**DEFENSE NUCLEAR FACILITIES
SAFETY BOARD**

Staff Report

Y-12 National Security Complex Criticality Safety Review

Figure 1. NCS Organization Staffing as of January 2019

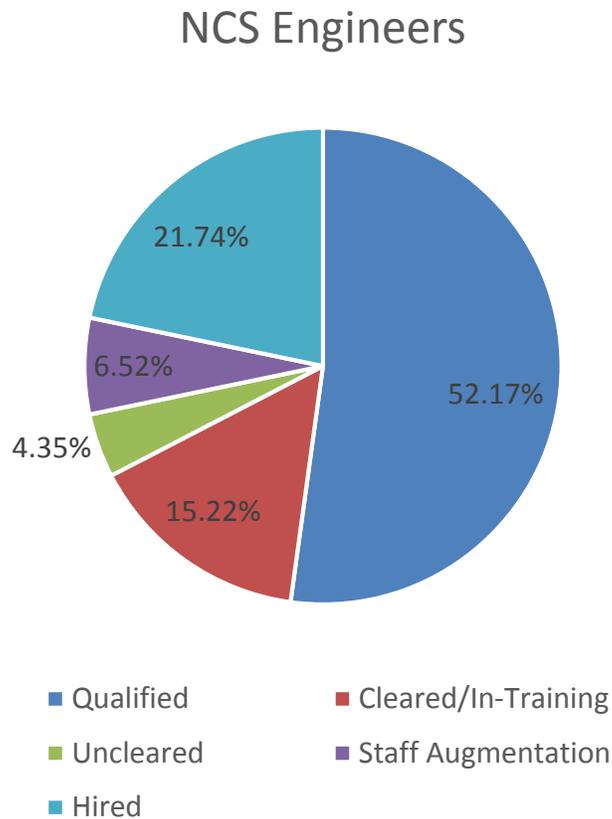
Inability of the NCS Organization to Adequately Maintain the Y-12 Criticality Safety Program—The Y-12 NCS organization lacks sufficient qualified staff to perform both CSP continuous improvement activities and Operations-directed work. As shown in Figure 1, approximately 52 percent of the engineers in the Y-12 NCS organization are qualified (including subcontractors identified as staff augmentation), the remainder are in-training. Qualifications for in-training NCS engineers have been delayed for various reasons, including delays in obtaining DOE security clearances. As of November 2018, the number of qualified NCS engineers does not match the number of NCS engineers required to meet the scope of work budgeted for a given fiscal year. Additionally, the site struggles to retain qualified engineers. On average the number of new NCS engineers hired has equaled the number of NCS engineers lost in a given fiscal year since FY 2015 [18-21].

The staff team acknowledges recent Y-12 efforts to increase NCS staffing. However, the staff team is concerned that the NCS organization cannot sufficiently staff both its commitments to Operations and to perform continuous improvement work on the CSP (e.g., updating/upgrading CSEs) until the number of qualified NCS engineers is increased. The staff team concludes the challenge of retaining NCS engineers will continue to put a strain on the
